MODIFICATION 01 - JUNE 2020
SCHEDULE OF CHANGES

MOD2020/0334

PROJECT
32 The Strand
Whale Beach, NSW, 2107
Lot 70 on DP11067

PHASE
DA
DWG NO
210.01
REV
C
schematic design

DRAWING NAME
sections
sheet 1

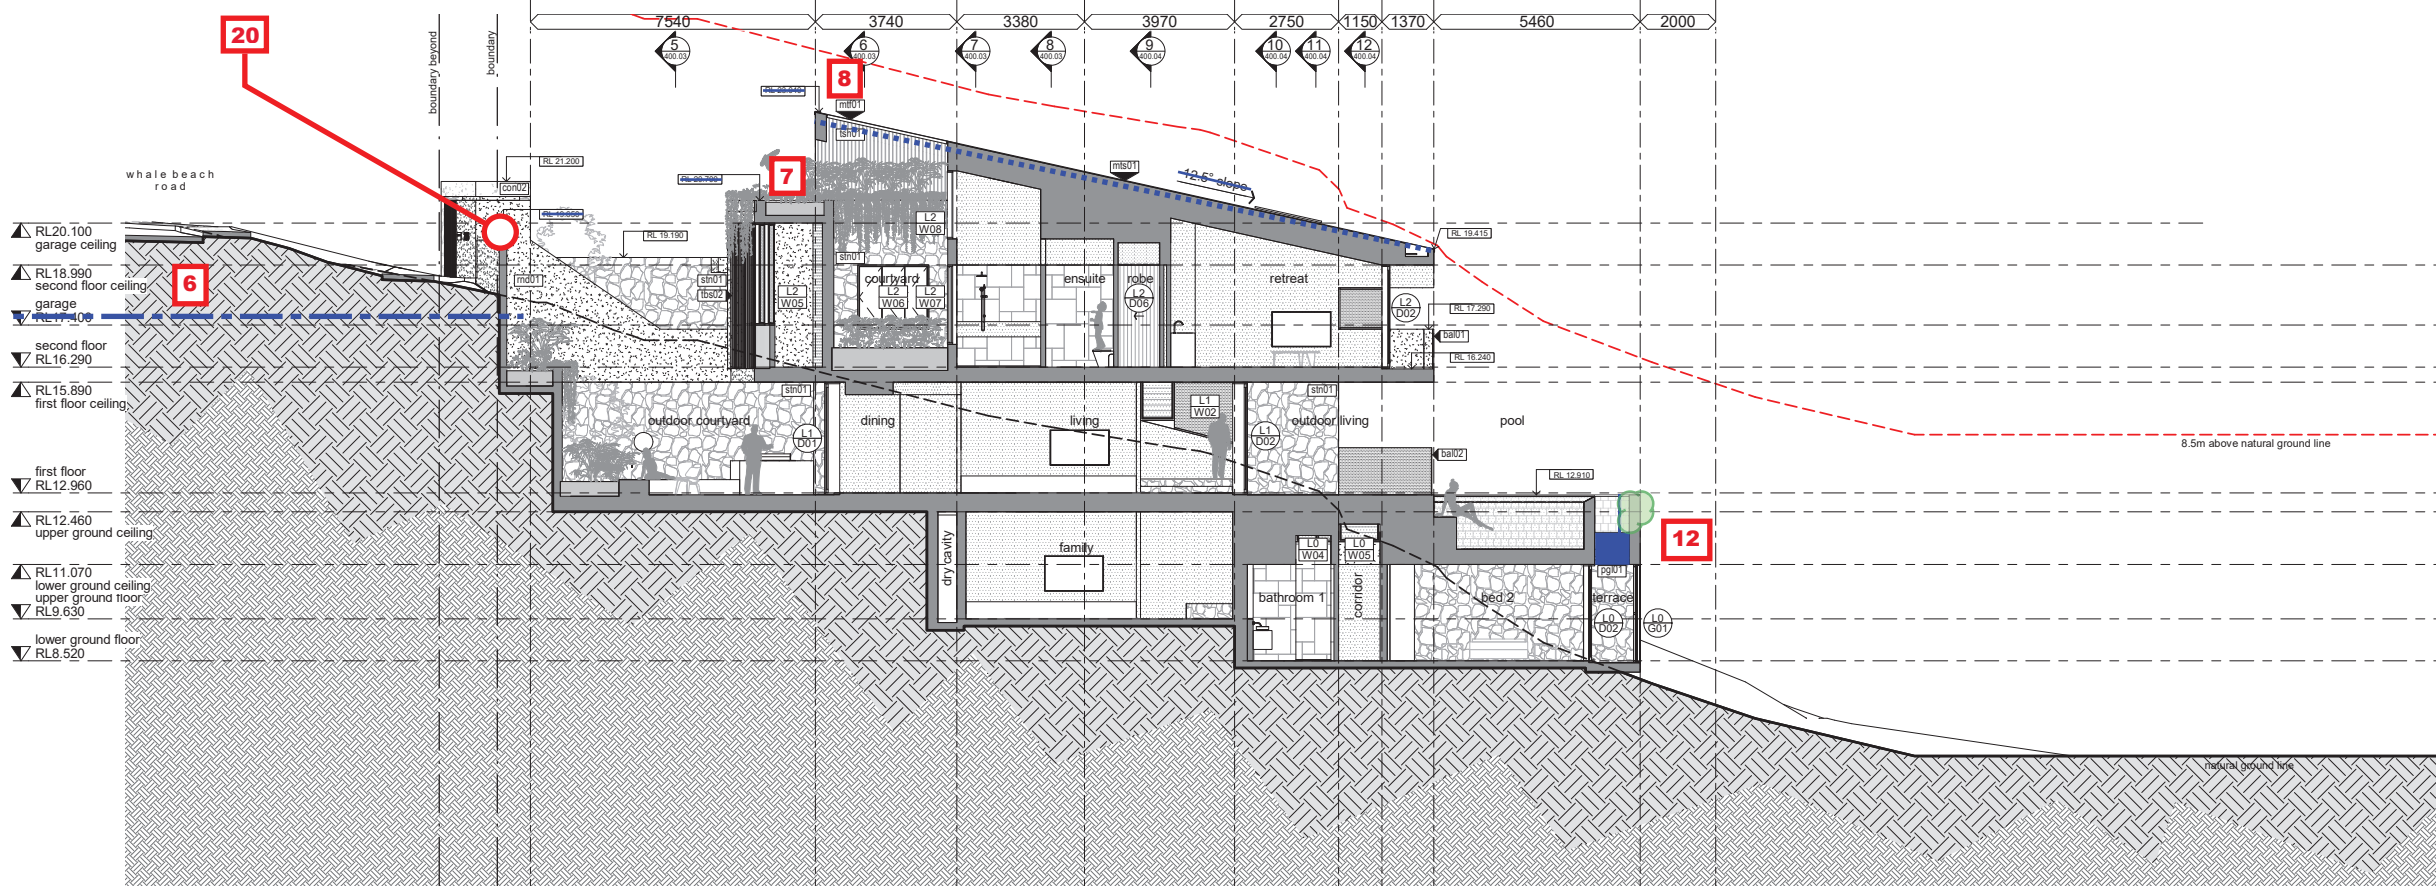
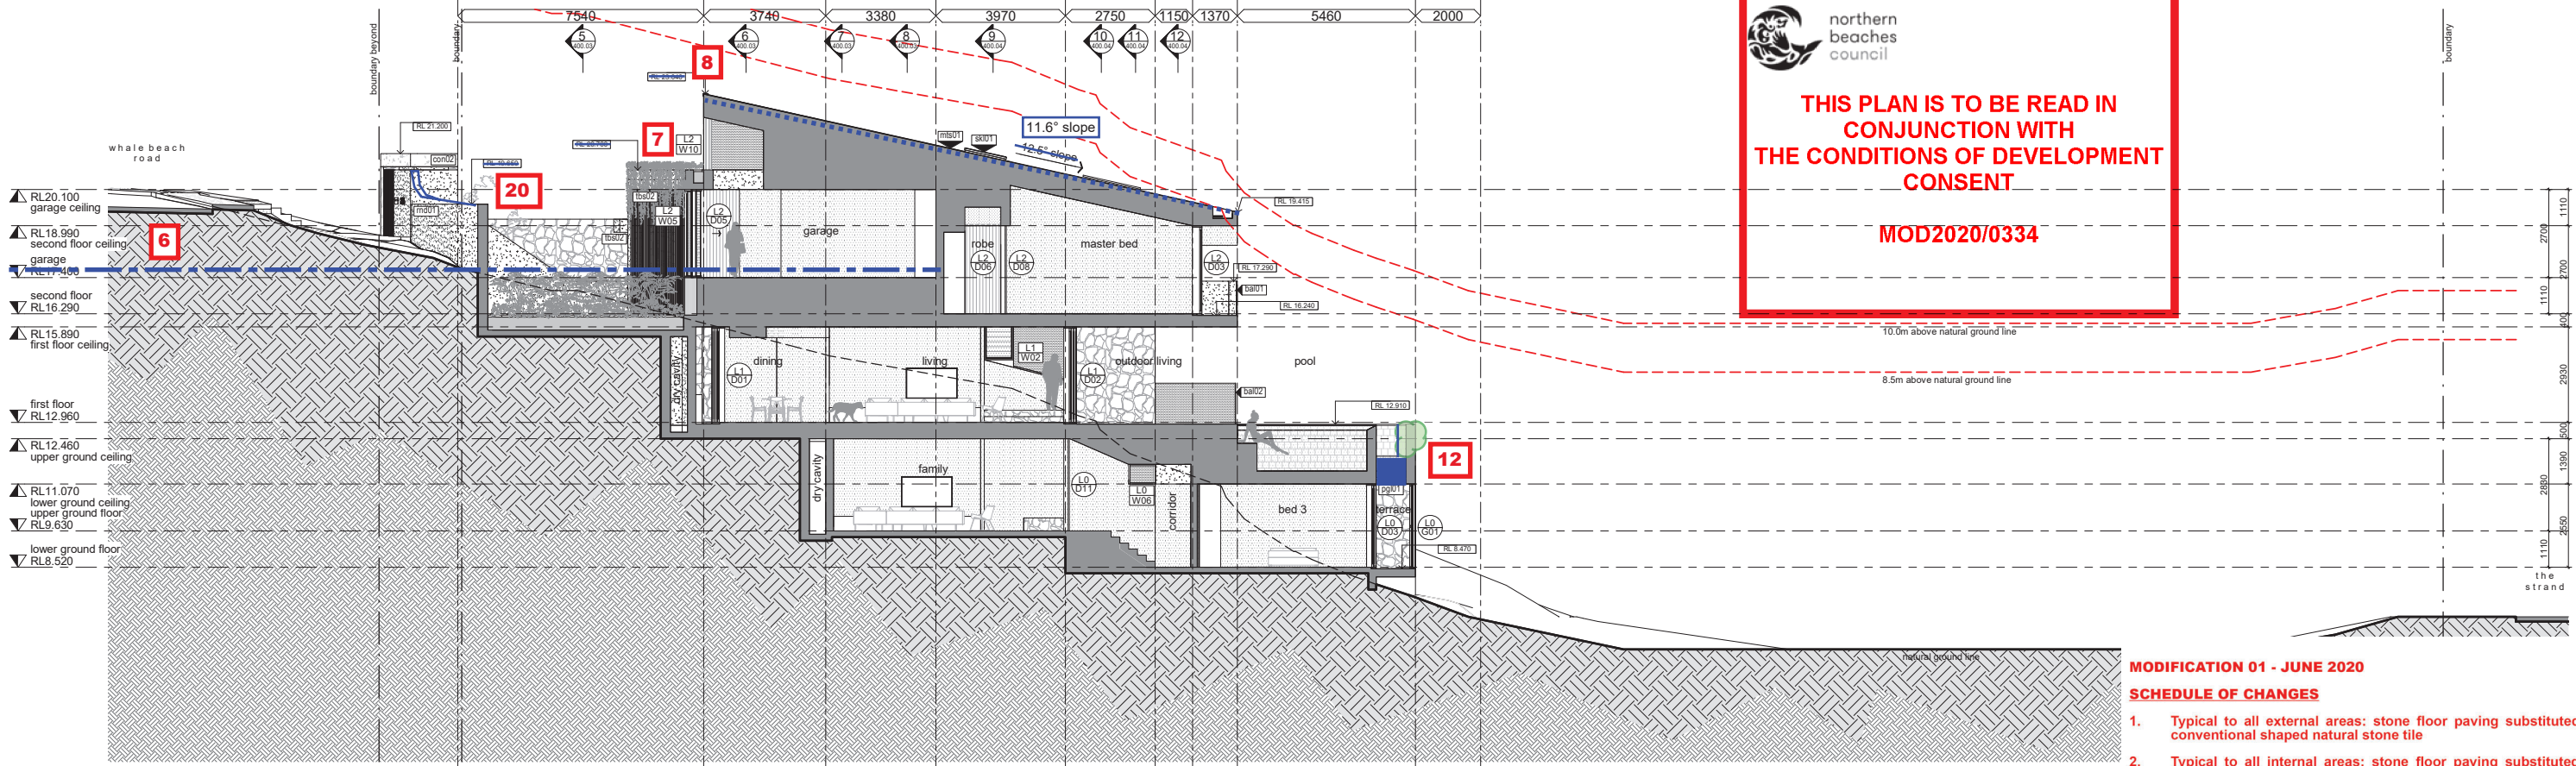
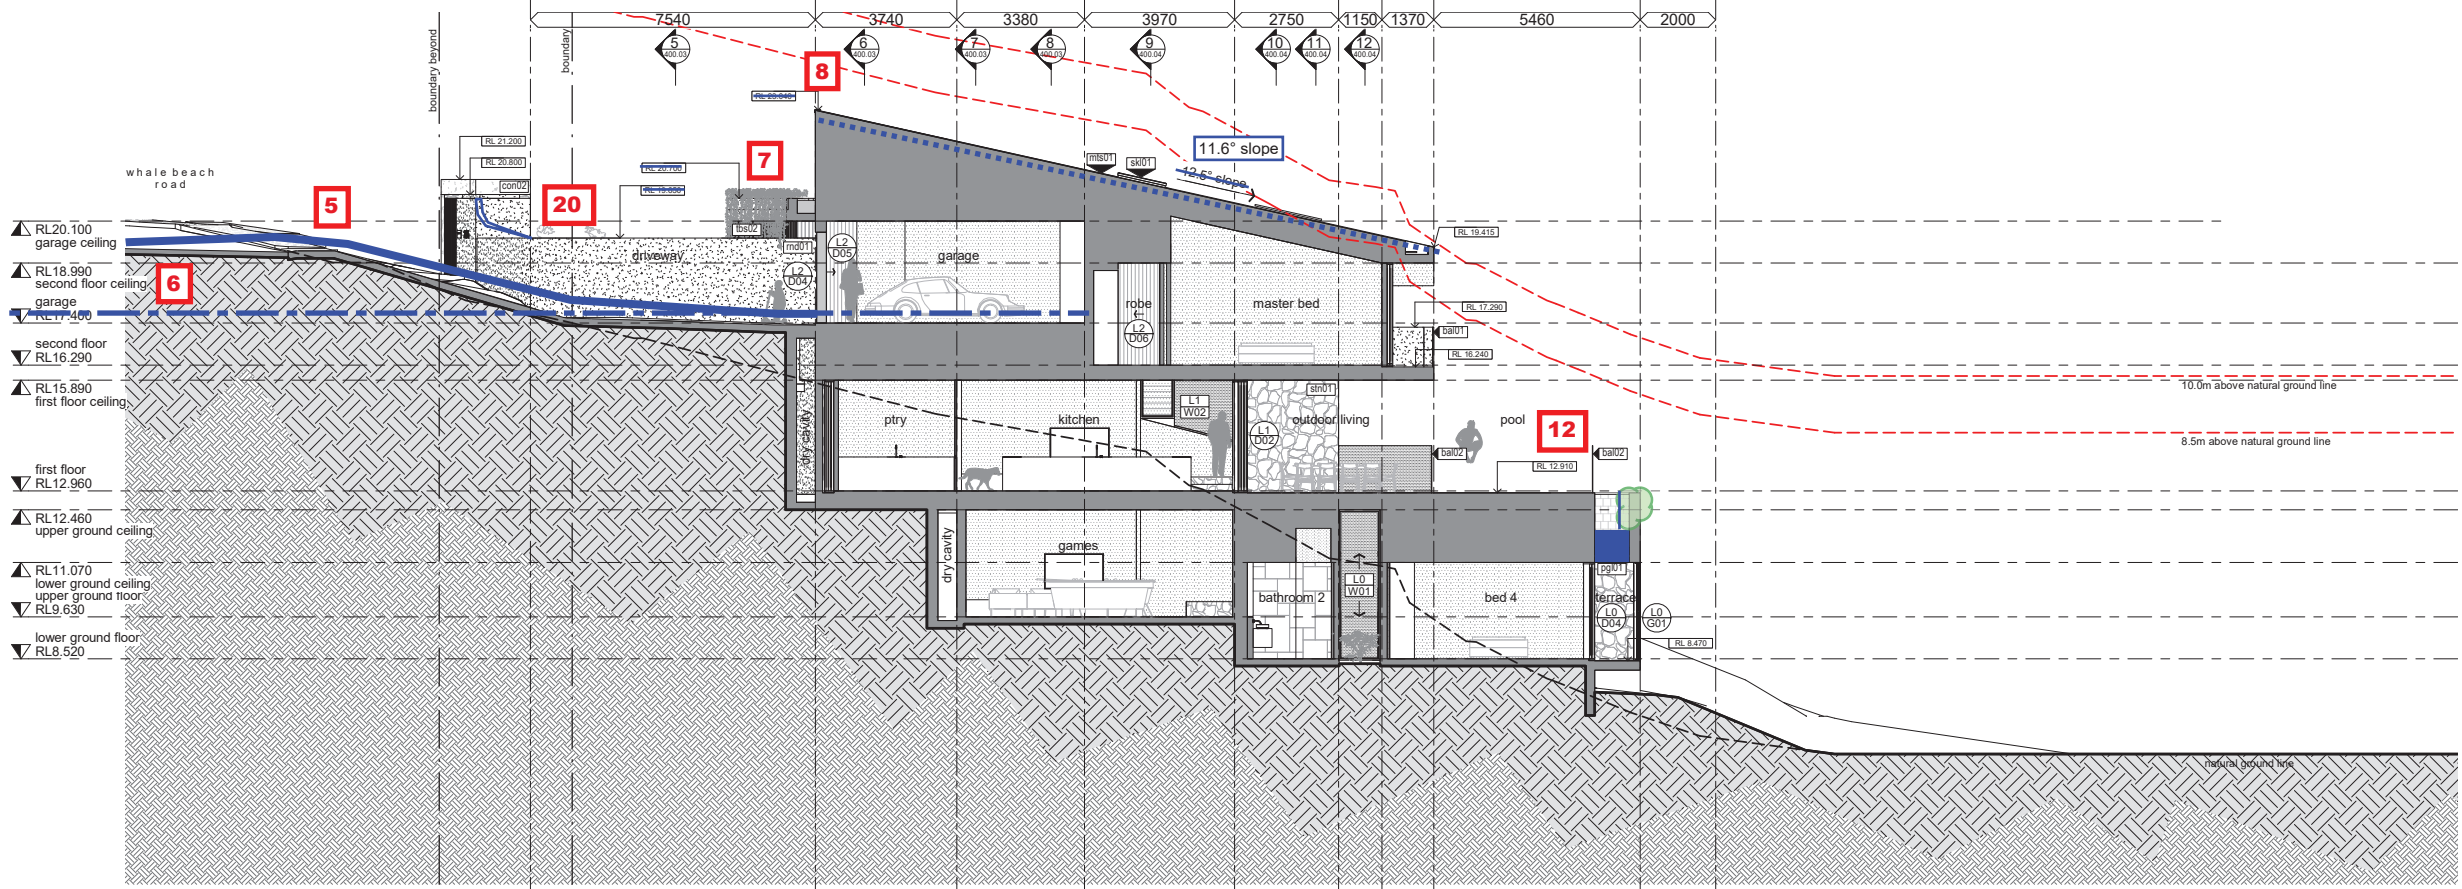
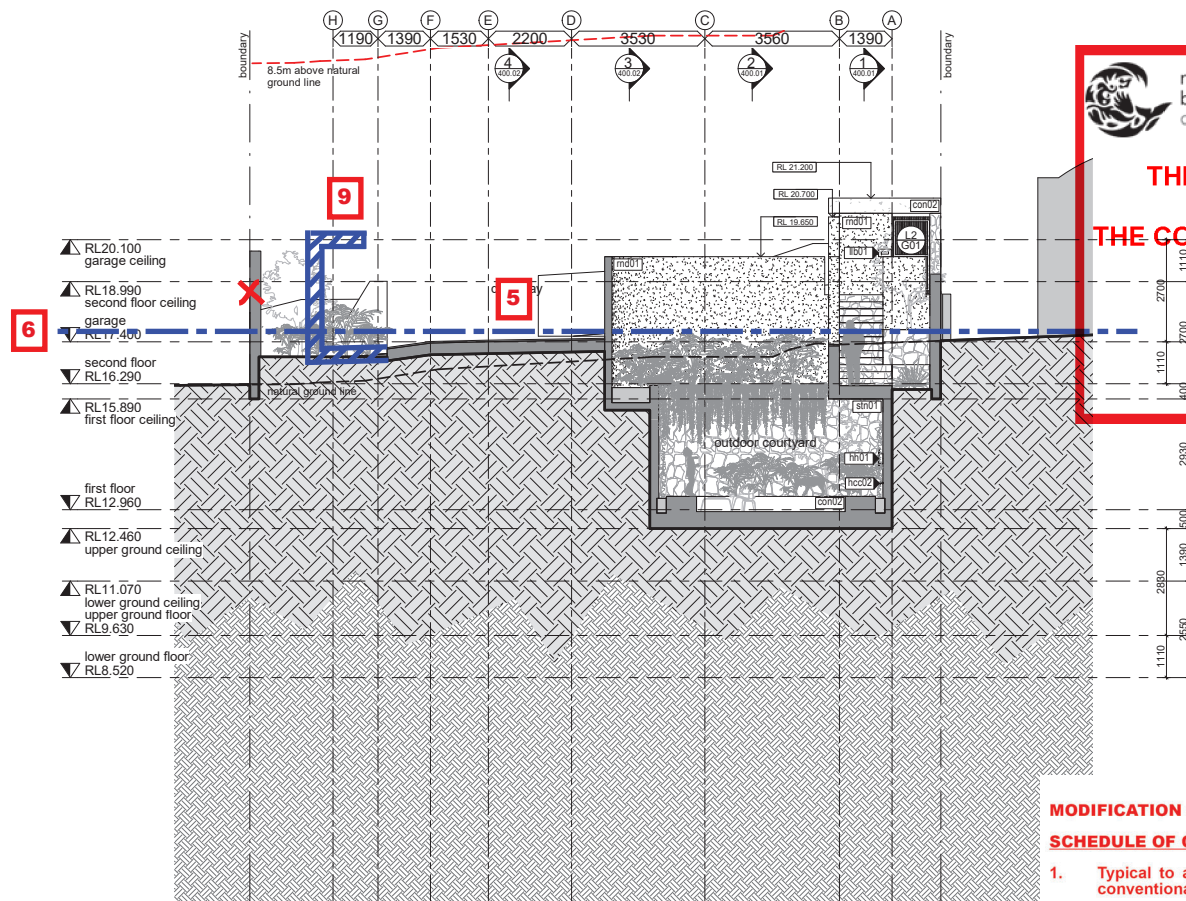
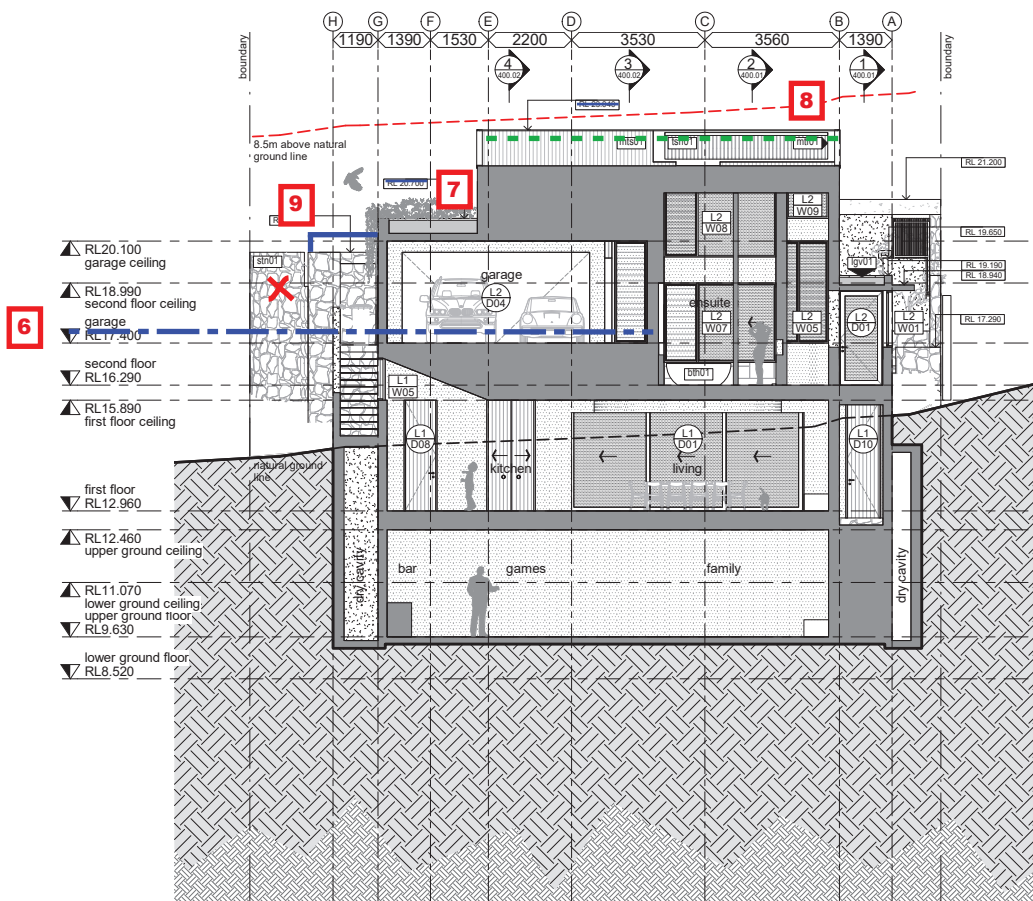
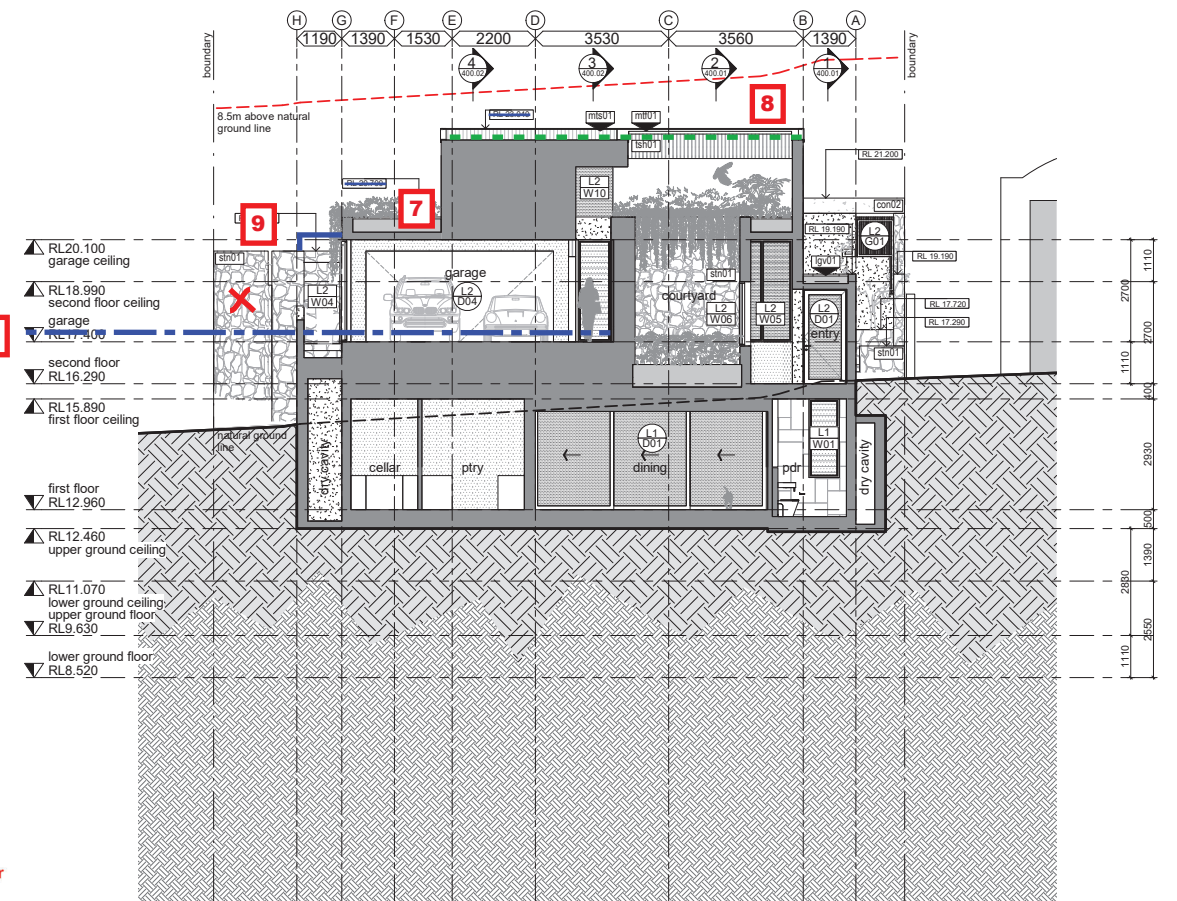
1. Typical to all external areas: stone floor paving substituted for conventional shaped natural stone tile
2. Typical to all internal areas: stone floor paving substituted for timber floors, and conventional shaped natural stone tiles in wet areas

3. Hard path and steps removed from architectural scope. Soft landscaping solution by landscape architect
4. Driveway finish changed and widened in accordance with consent SL2020/0241

5. Driveway levels modified to suit Council requirements in accordance with consent SL2020/0241. Car turntable added
6. Garage level raised by 300mm to RL17.700 as a result of accommodating [5]

7. Garage roof and garden edge lifted 150mm to RL20.850 as a result of accommodating [5] and [6].
8. Main roof ridge lowered by 290mm to RL22.750 as a courtesy to improve the view amenity of a neighbour to the west. Roof slope adjusted to 11.6 degrees.

9. Bin store reshaped and curved wall deleted. Bin store lid level shown at RL20.150. Refer to plans for dims where appropriate. Alteration in part as a result of compliance with prescribed conditions of consent (23) + (25) relating to tree protection and arborist's recommendations.

10. Minor alteration to configuration of glazing. Fixed glass to study. Glazed swing door out of laundry. Note net area and amount of glass remains unchanged.

11. Minor alteration to configuration of glazing. Refer to plan for relocation of walls. Note net area and amount of glass remains unchanged, floor area slightly reduced.

12. Swimming pool infinity edges (and associated ballast tank) deleted and zone changed to accessible path and landscaped wall/planter
13. Steps introduced to pool terrace to access service path. Refer to plans for dims where appropriate.

14. Extra solar panels added to increase energy efficiency of development
15. Block wall moved down to align with pool equipment adjacent as shown. Note this change is underground and not visible to the public or neighbours.

16. Plant and equipment store area increased by moving western wall further west in order to accommodate the required equipment with ventilation and service space. Refer to plans for dims where appropriate.

17. Block wall to be changed to screening for ventilation and sound attenuation
18. Seat added
19. Landscape plan amended in accordance with prescribed conditions of consent (15) + (38).

20. Height of landscaped wall facing street to be increased to the North to a max height of 1800mm above ground level to follow natural topography.
